## ADDENDUM NO. 2

Replace Roofs – Laundry & Print Shop  
Moberly Correctional Center  
Moberly, Missouri  
PROJECT NO.: C1913-02

Bid Opening Date: 1:30 PM, Thursday, June 25, 2020

SHEET TITLE:  
LAUNDRY / PRINT SHOP  
BUILDING No. 13  
ROOF DEMOLITION PLAN

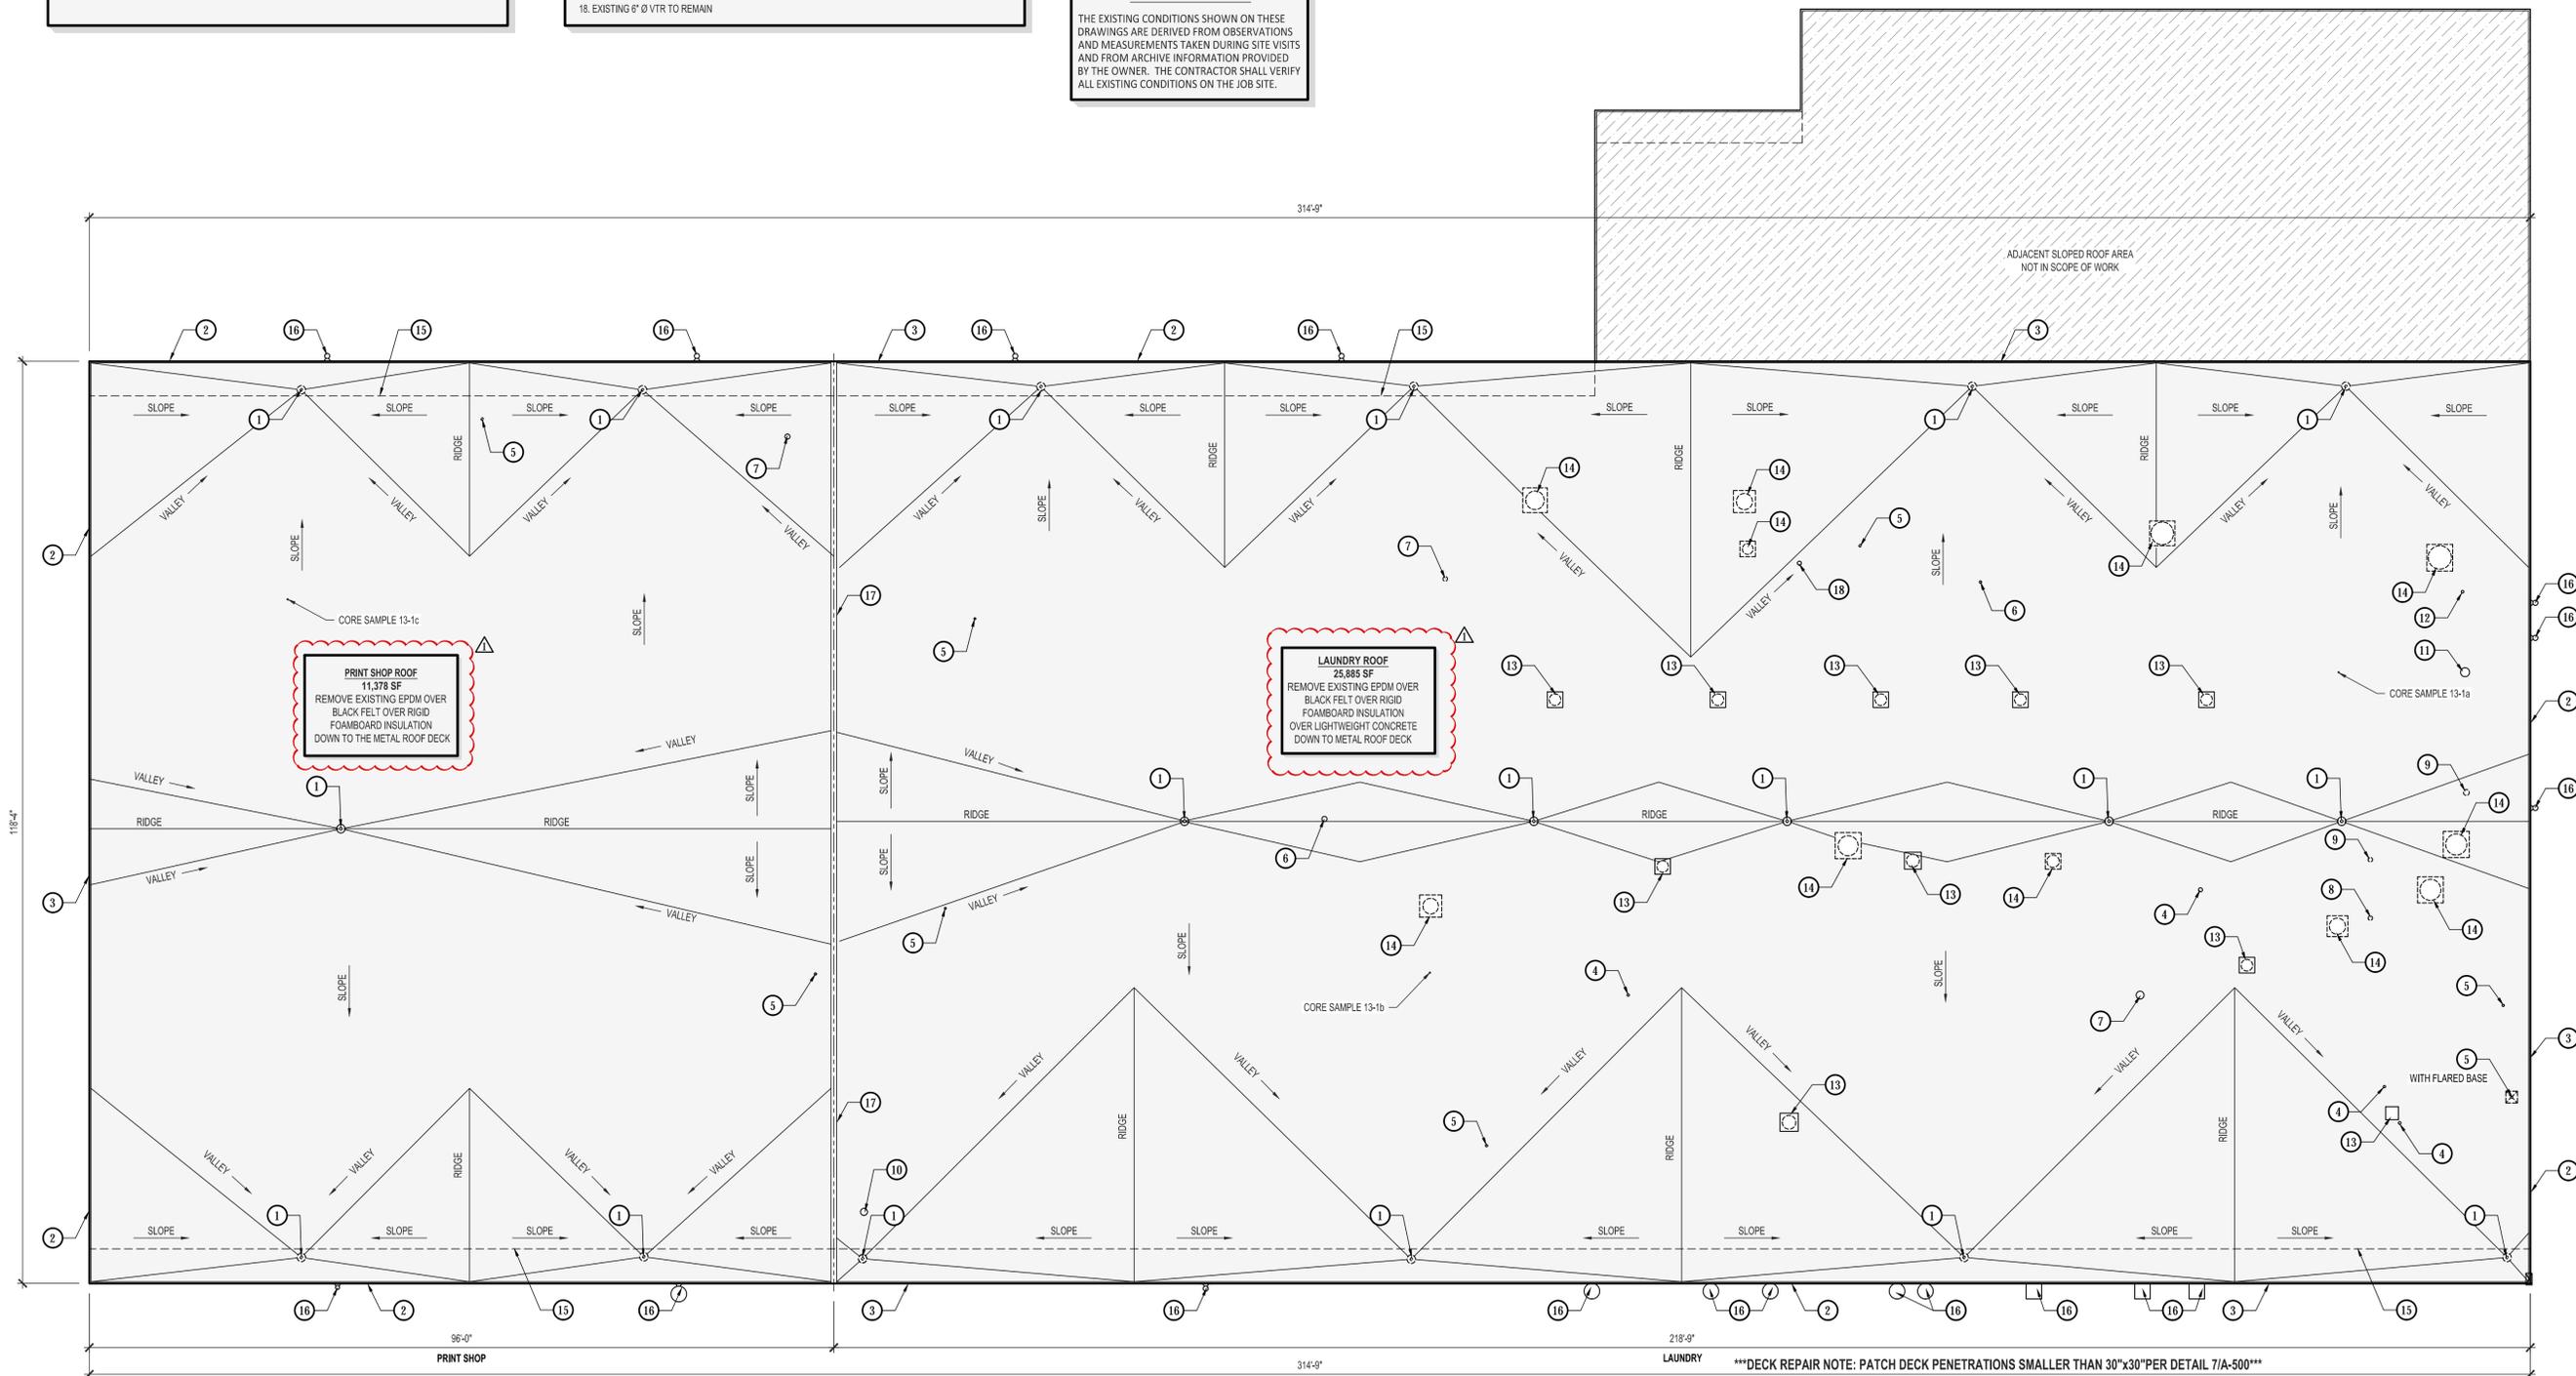
- a. REPLACE with the Revised Drawing AD-100 LAUNDRY/PRINT SHOP BUILDINGS NO. 13 Roof Demolition Plan (attached)

- KEYED ROOF DEMOLITION NOTES: LAUNDRY / PRINT SHOP BUILDINGS No. 13**
- EXISTING ROOF DRAIN TO REMAIN WITH 8" Ø DOME STRAINER TO BE REMOVED
  - EXISTING MULTI-COURSED METAL FASCIA - REMOVE TOP COURSE

- EXISTING PARAPET TO REMAIN - BASE BID INCLUDES THE REPLACEMENT OF 1,800 LF OF 2x4 BLOCKING. REFER TO SECTION 012200 UNIT PRICES.
  - EXISTING 4" Ø CAST IRON VTR TO REMAIN

SHEET TITLE:  
LAUNDRY / PRINT SHOP  
BUILDING No. 13  
ROOF REPLACEMENT PLAN

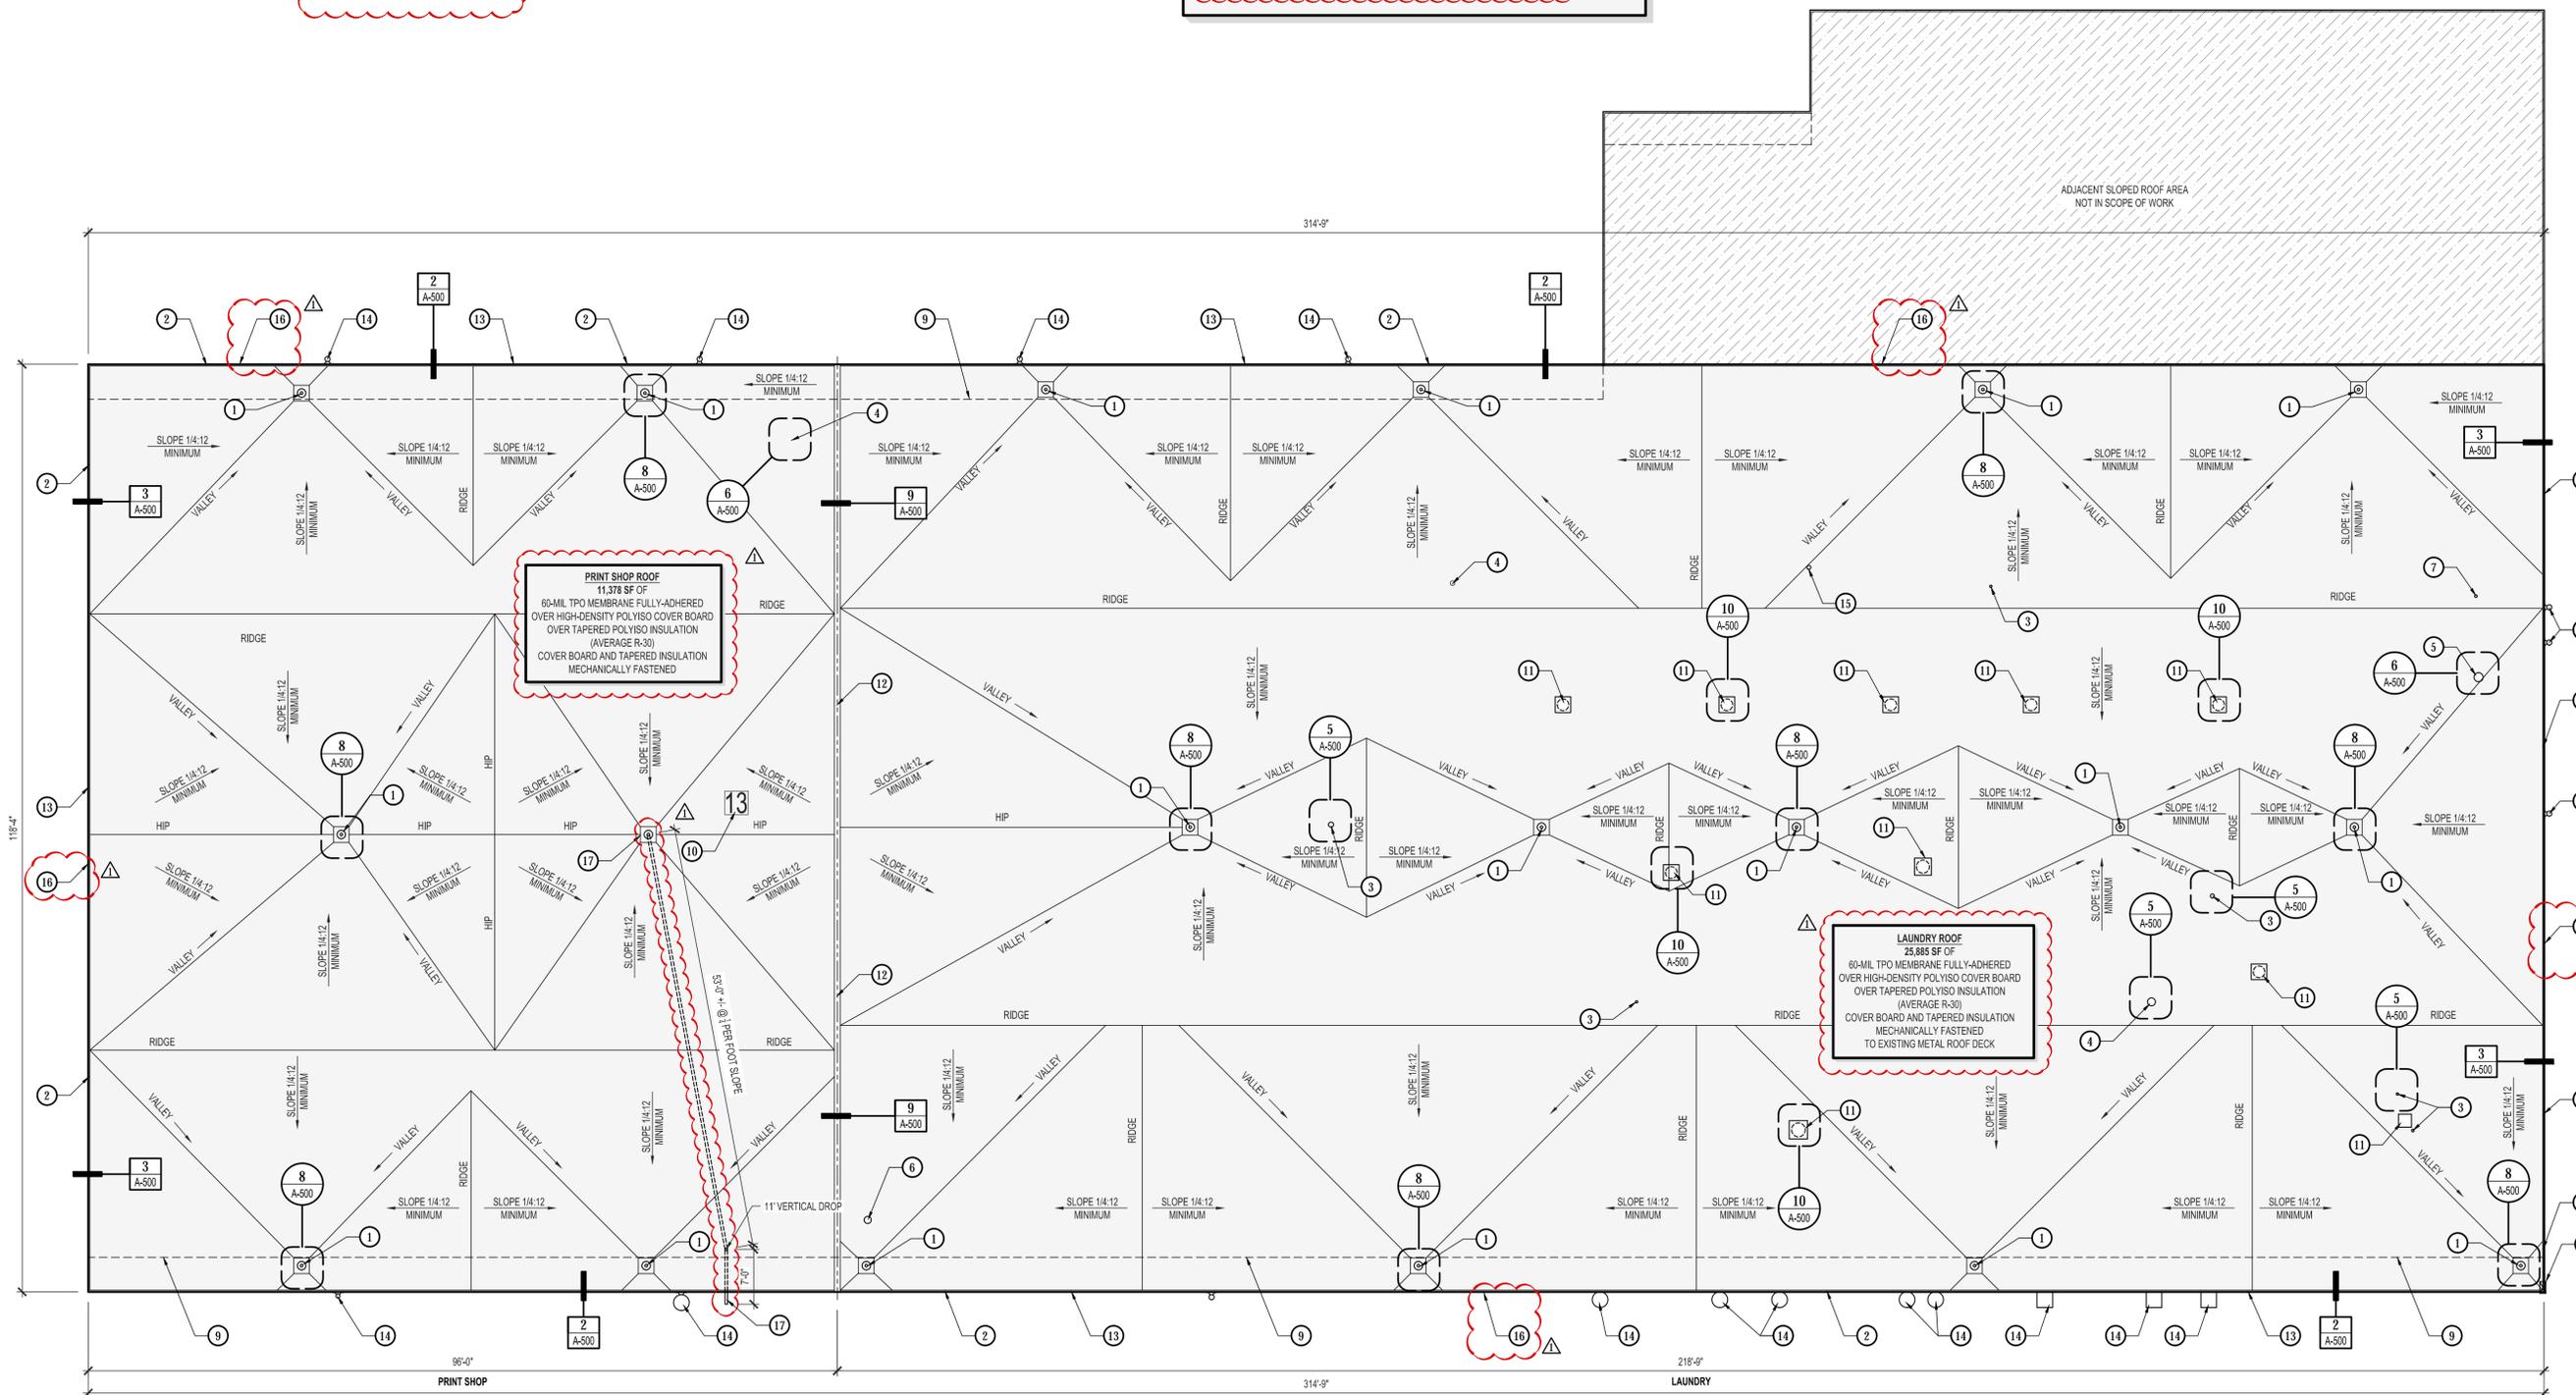
- a. REPLACE with Revised Drawing A-100 Laundry/Print Shop Building No. 13 Roof Replacement Plan (attached)

1. NEW 8"  $\emptyset$  DOME STRAINER OVER EXISTING ROOF DRAIN
2. EXISTING PARAPET - BASE BID INCLUDES REPLACEMENT OF 1,800 LF OF 2x4 WOOD BLOCKING  $\Delta$

16. INSTALL NEW SNAP-ON FASCIA SYSTEM @ ROOF PARAPET  $\Delta$
17. INSTALL NEW INTERIOR ROOF DRAIN - MATCH ADJACENT ROOF DRAIN & 4" PVC PIPING DISCHARGE A MINIMUM OF 6' AWAY FROM FACE OF BUILDING  $\Delta$

1. MINIMUM FLAT ROOF SLOPE: 1/4" PER FOOT.
2. MINIMUM AVERAGE R-VALUE R-30 (FLAT ROOF AREA)
3. BASE BID - REPLACE 2,800 SF OF METAL DECK - REPLACEMENT DECK MUST MATCH EXISTING PROFILE. REFER TO SECTION 012200 UNIT PRICES.
4. BASE BID - REPLACE 1,800 LF OF 2x4 WOOD PARAPET BLOCKING. REFER TO SECTION 012200 UNIT PRICES.  $\Delta$

ROOF CONTOUR MAP HAS ADJUSTED  $\Delta$

FLAT ROOF  
TPO DETAILS

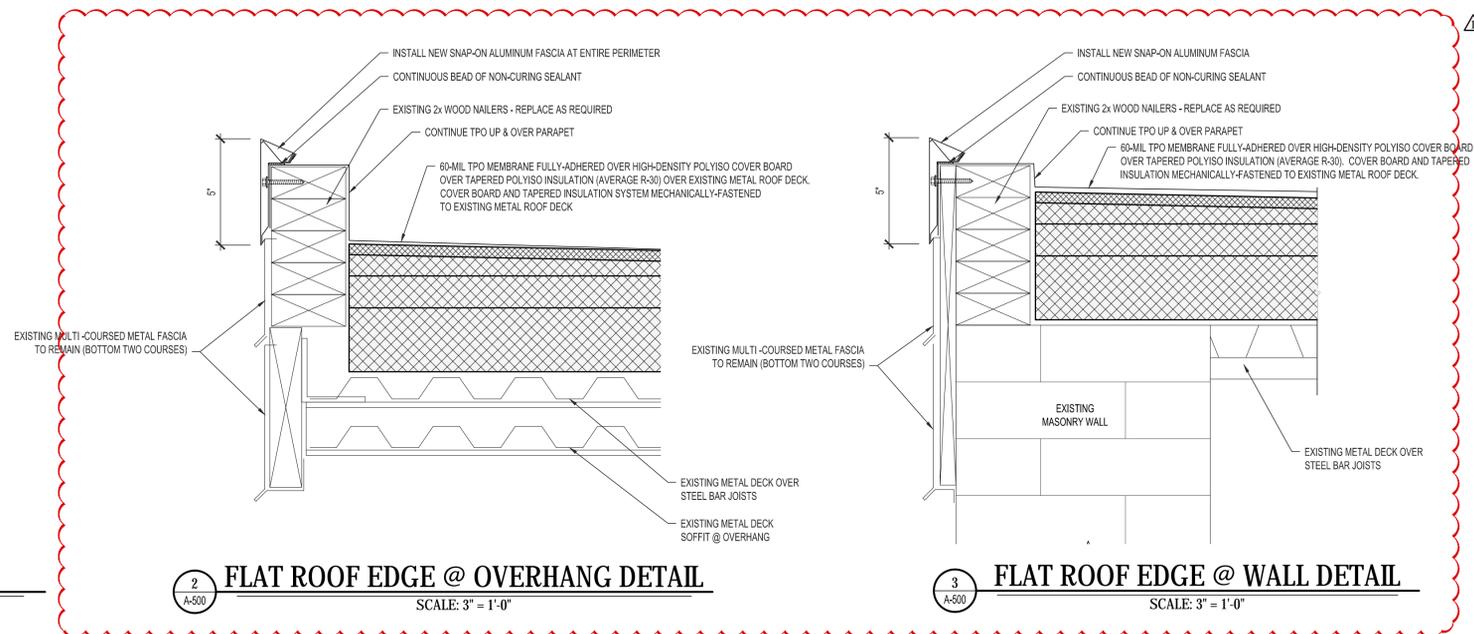
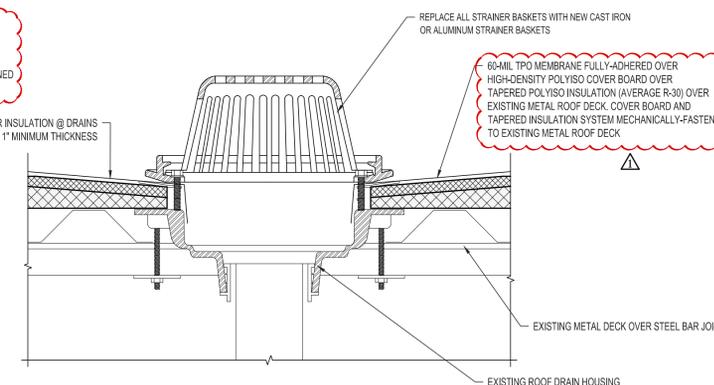
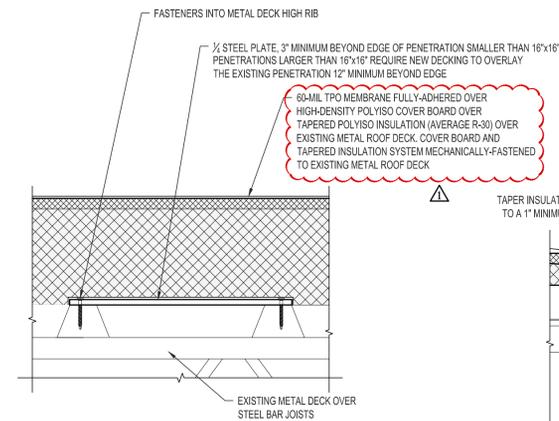
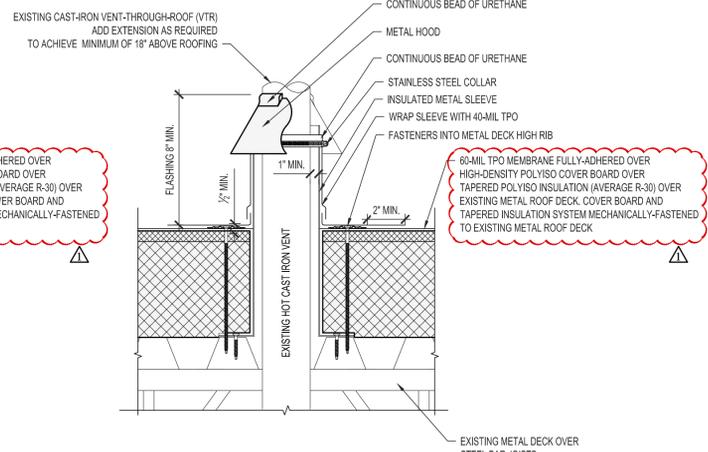
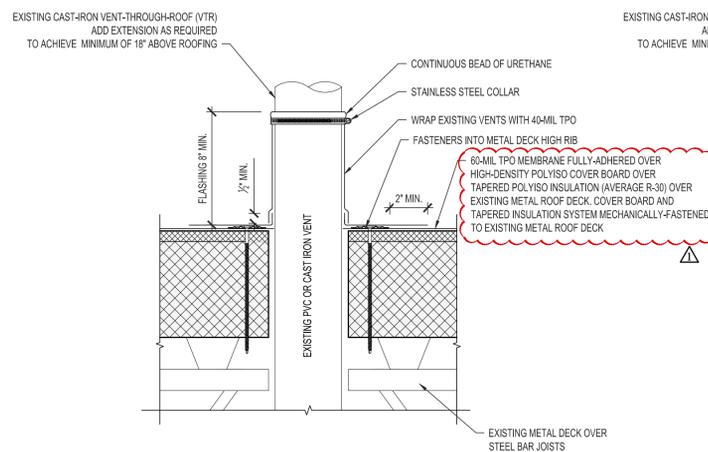
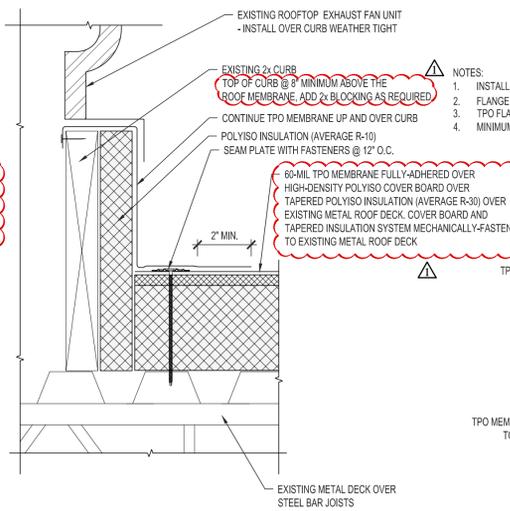
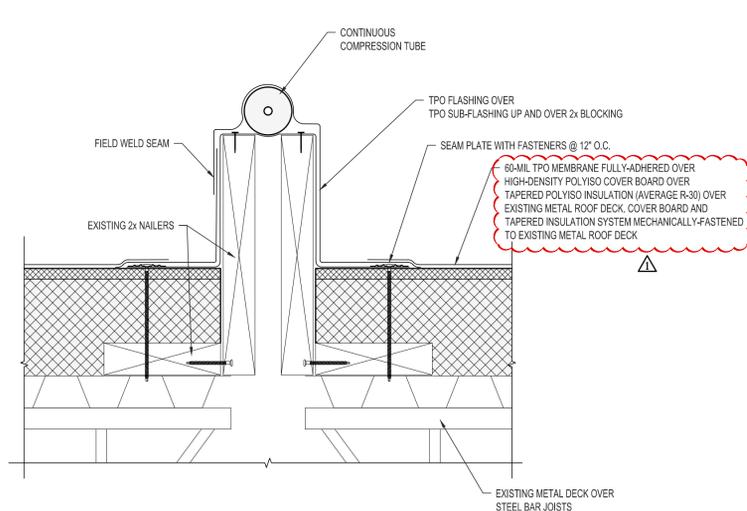
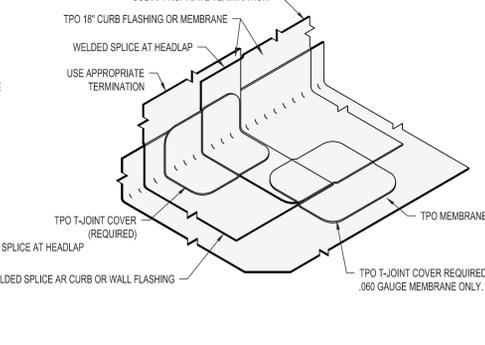
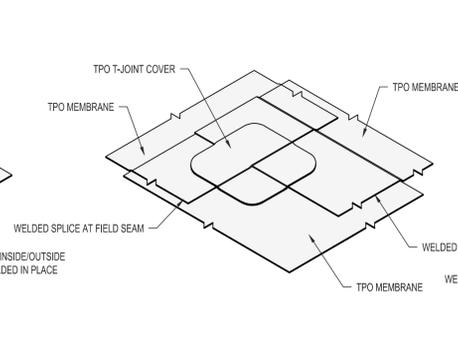
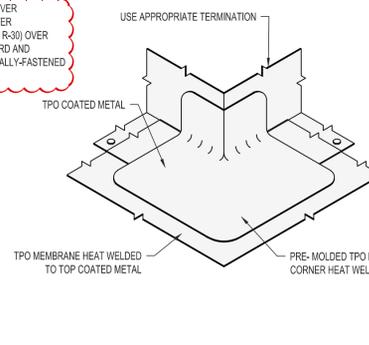
- a. REPLACE with Revised Drawing A-500 Flat Roof TPO Details (attached)

\*\*\*DECK REPAIR NOTE: PATCH DECK PENETRATIONS SMALLER THAN 30x30 PER DETAIL 7/A-500\*\*\*
